BULLI AGED CARE CENTRE OF EXCELLENCE

OBJECTION SUBMISSION ON PROPOSAL
SSD 7751

OBJECTION STATEMENT

ARBORIST REPORT 28 JUNE 2016

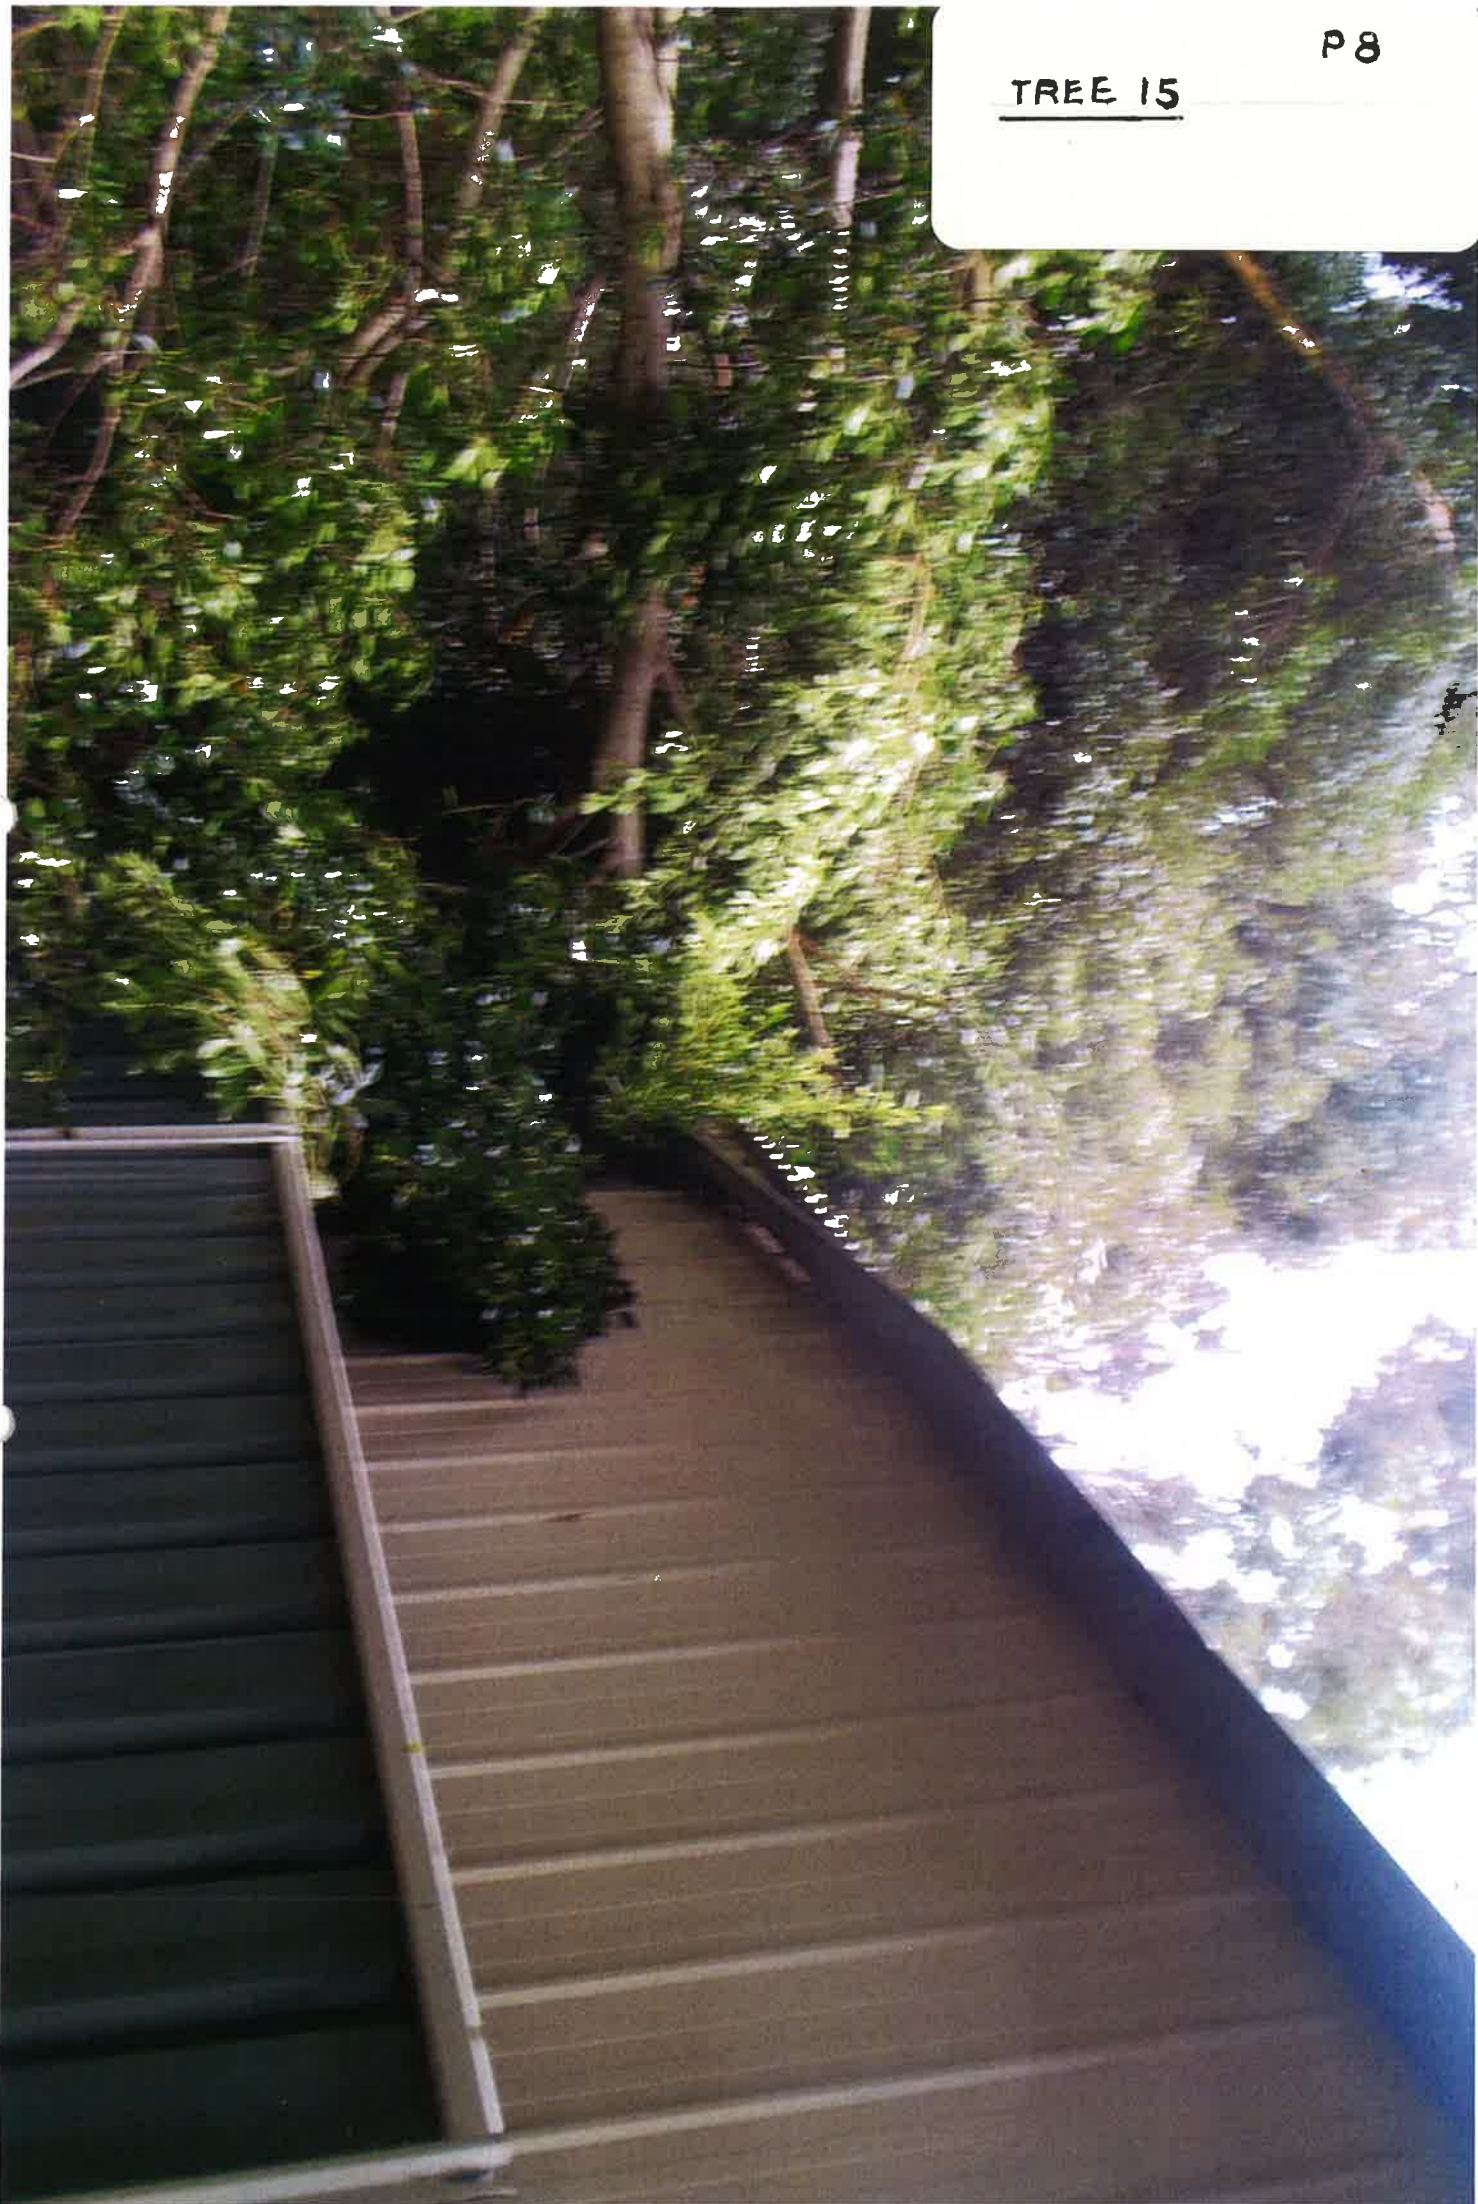
STATES:- TREES 11-19 HILLS WEEPING FIG COUNCIL
MAY APPROVE THEIR REMOVAL HOW EVER DO
PROVIDE A LARGE SCREEN AREA ALONG THE
NORTHERN FENCE. THESE TREES WILL
POTENTIALLY DOUBLE IN SIZE BOTH HEIGHT AND
WIDTH.

OBJECTION:- TREES ALREADY - DANGEROUS - REMOVE THEM

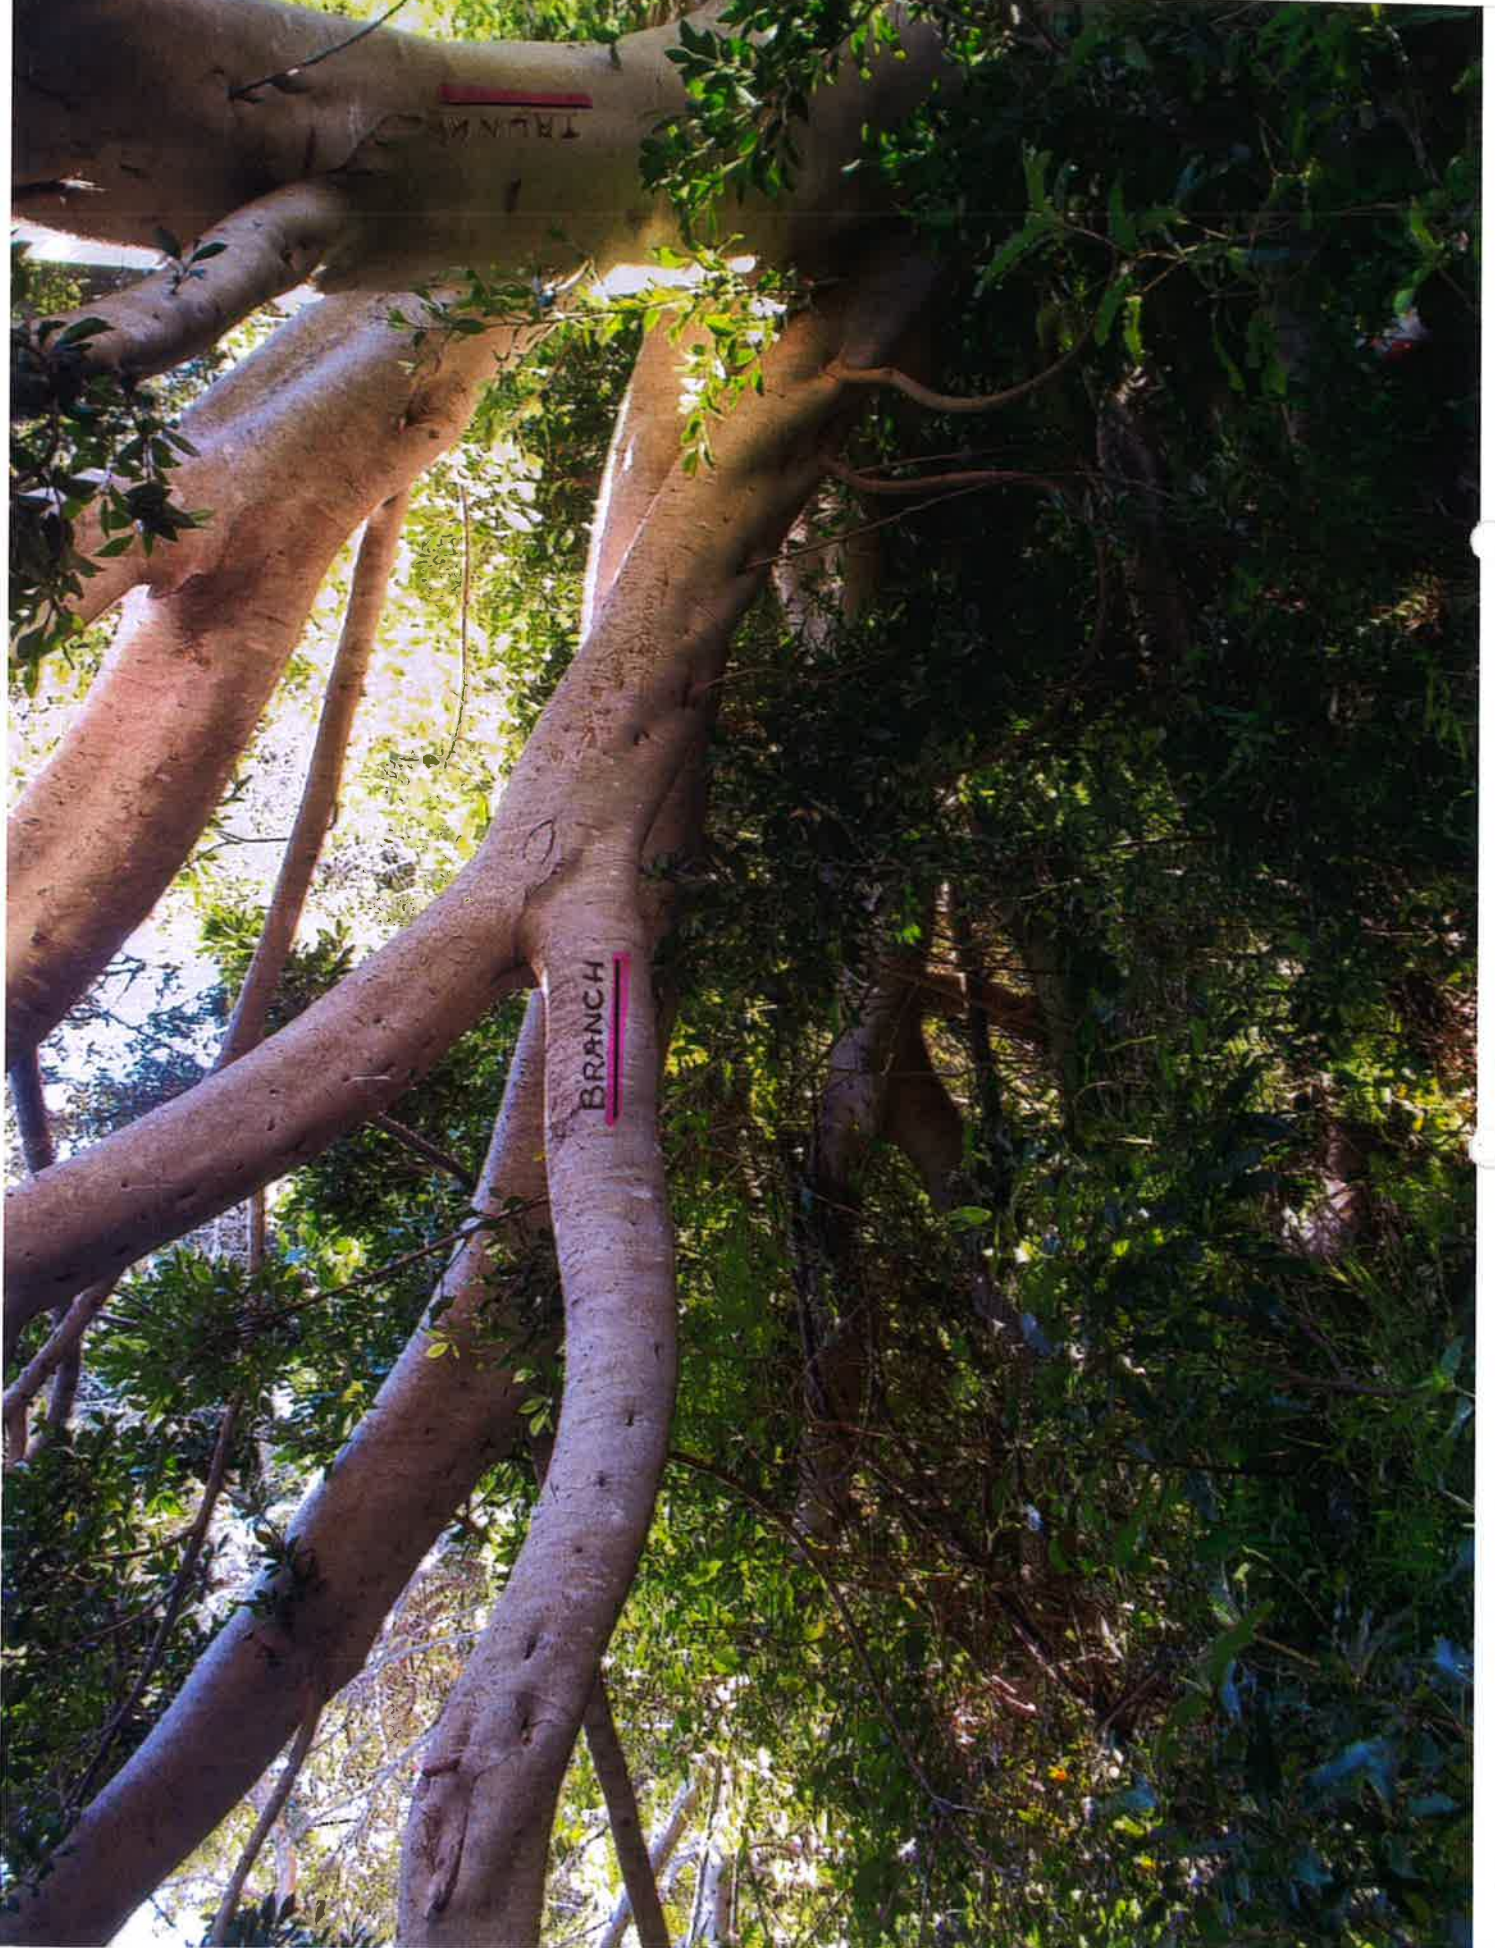
TREE 15

ON GRACE

TREE 15

TRUNK DAMAGE SHOWS
DIRT START OF SPLIT

TREE 15

BRANCH

FALLEN TREE SSTILL REMAIN NOT SHOWNON ARBORIST LOCATIONPLAN-EAST OF TREE 12

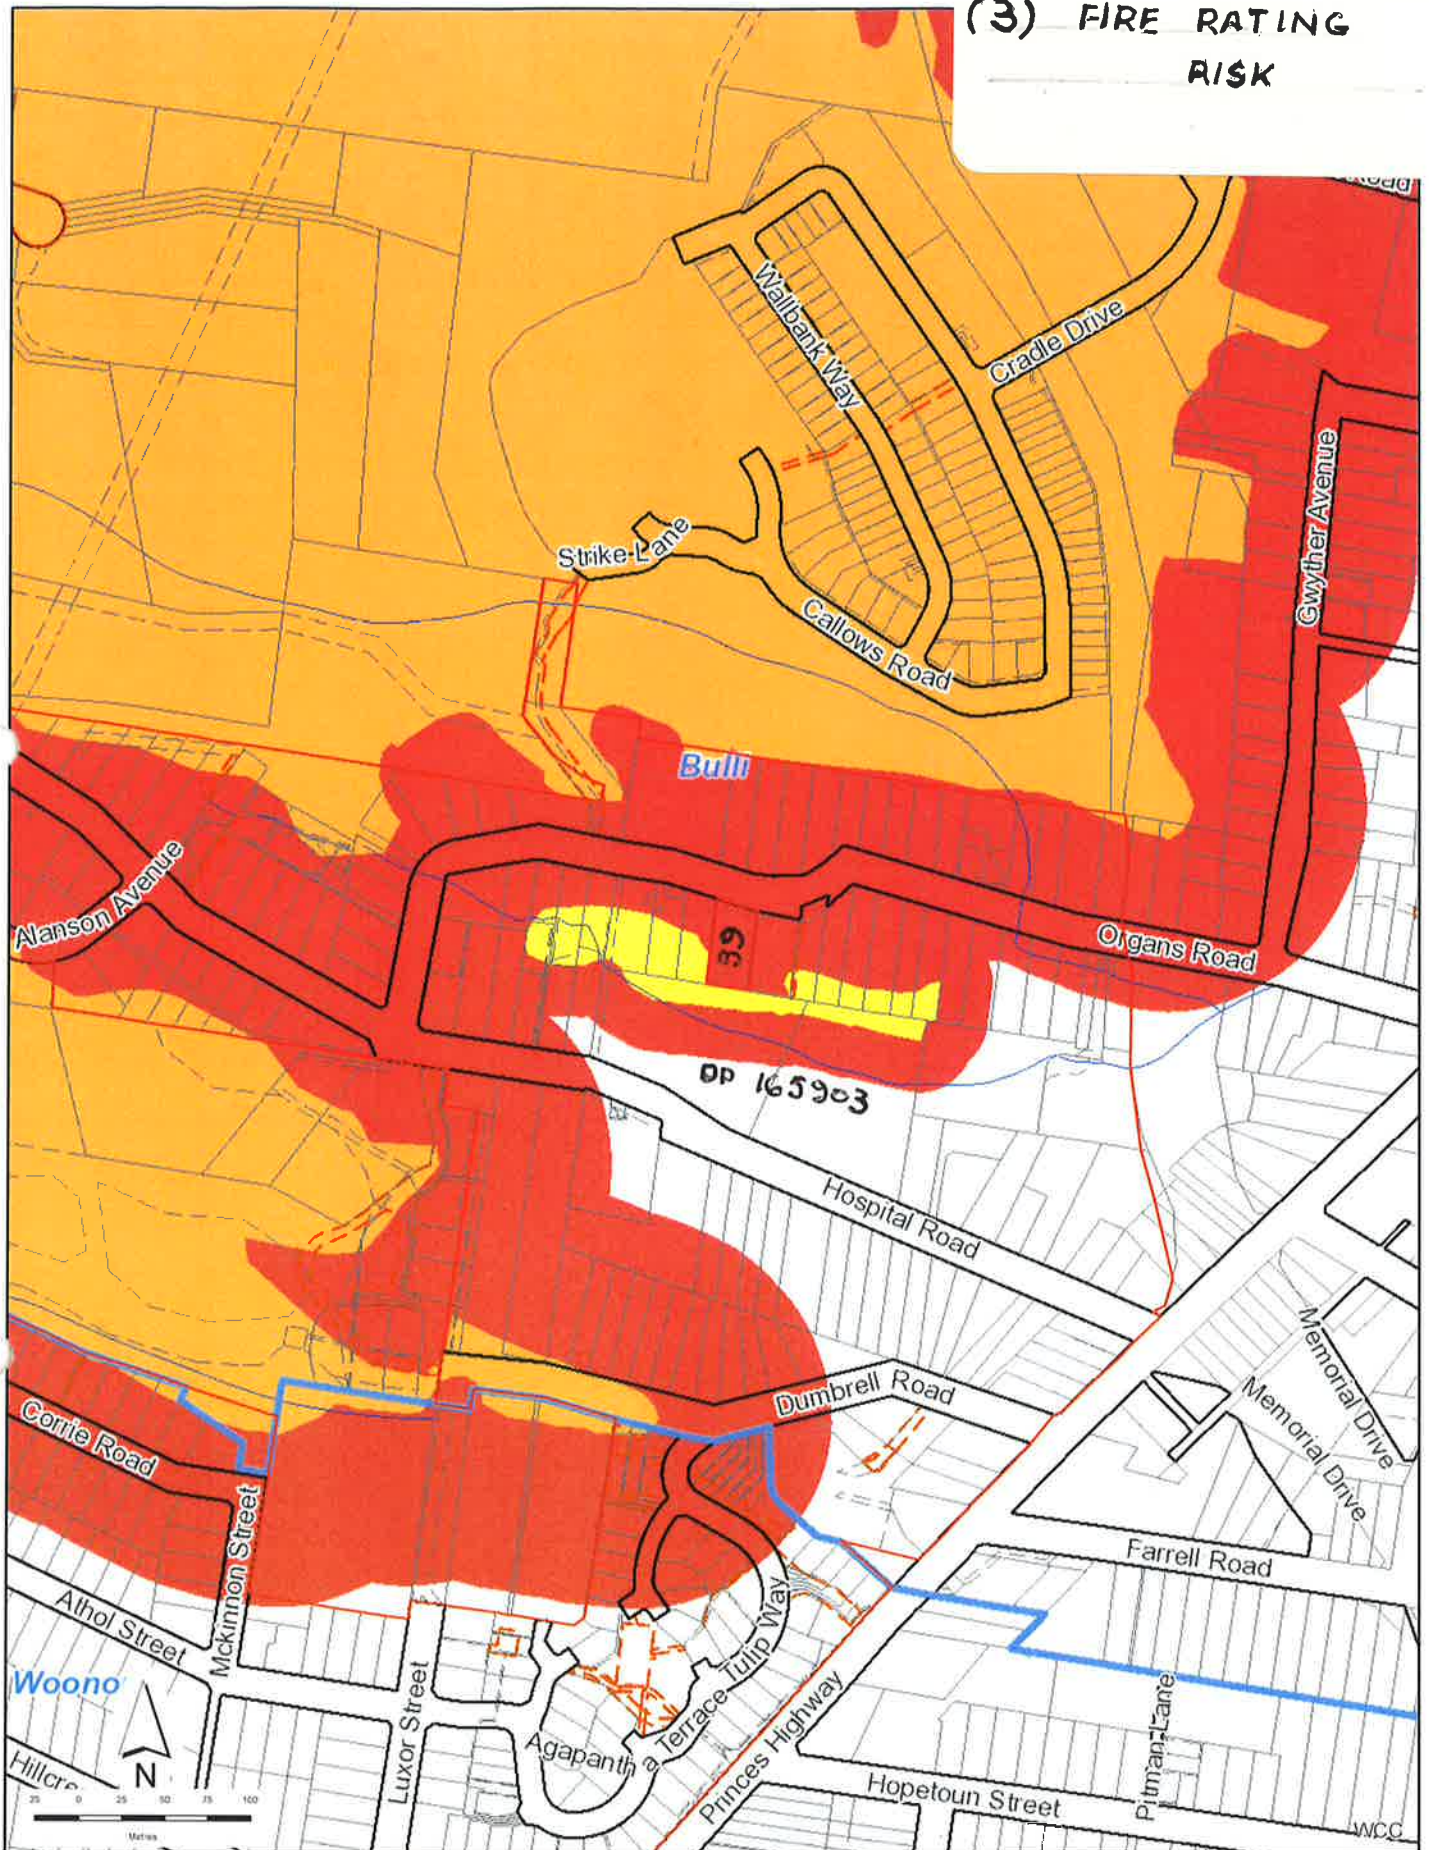
TREE 14 BRANCHES
SPLIT OFF LAYING
IN CARPARK

TREE 14 SHOWING
DIRT-UNUSUAL GRAIN
STRUCTURE NOT CONNECTED
TO TRUNK

TREE 14
BRANCHES REMOVED
REMAINS ON SITE
INTERESTING V SECTION

Figure 2 – Bushfire prone land map

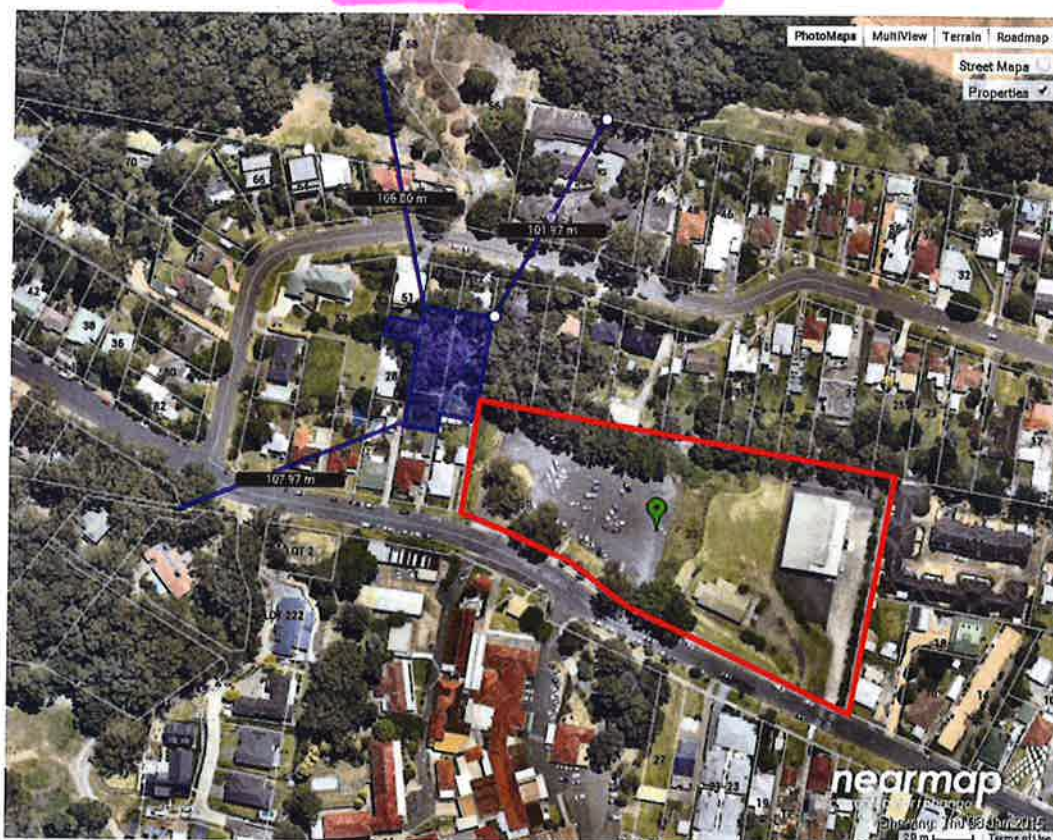
BUSH FIRE ASSESSMENT BY TRAVERS BUSHFIRE ECOLOGY FOR THE SUBJECT SITE. STATE THE SITE IS MAPPED BUSHFIRE PRONE AND PROPERTYS TO THE NORTH ARE MANAGED LAND. THEY RECOMMEND WOLLONGONG COUNCIL UPDATE THEIR BUSHFIRE PRONE MAP WHICH WILL RESULT IN THE REMOVAL OF CATEGORY 2 (YELLOW) BUFFER (RED) FROM THE SUBJECT SITE.

ONE WOULD THINK (RED) FLAME ZONE - (YELLOW) BUFFER ZONE - VERY STRANGE - RED = STOP - DANGER
YELLOW SECTION SHOWN IN FIG 1 TRAVERS REPORT AND WOLLONGONG COUNCIL MAP IS THE AREA ON THE NORTH BOUNDRY OF LARGE TREES AND SCRUB

THIS YELLOW SECTION WILL BURN - THIS IS WHY OUR INSURANCE RATES US BAL-FZ (FLAME ZONE)

DA.01.0502

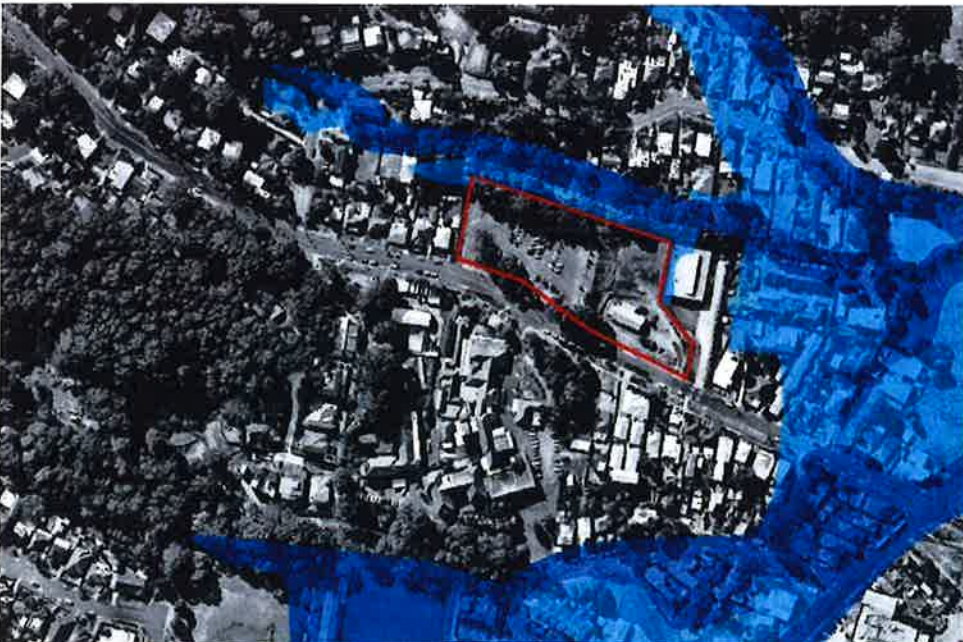
FLOODING SECTION 9.2.4 APPENDIX 10 OF SUBJECT SITE SHOWS MINOR FLOODING AT REAR OF AMBULANCE STATION NORTH WEST CORNER. ON DRG N° DA 010502 THIS DRAWING ALSO SHOWS HIGH RISK AND LOW RISK FLOODING IN OUR BACK YARD AT MUCH HIGHER RL WITH PROPOSED URGENT CARE UNIT BETWEEN BOTH LEVELS THIS DIFFERENCE IN LEVEL IS IN METERS BUT DOES NOT SHOW UP HAVING ANY AFFECT ON PROPOSED BULLI HOSPITAL URGENT CARE UNIT. SEE P 24

MAYBE THE PATIENTS CAN SWIM.
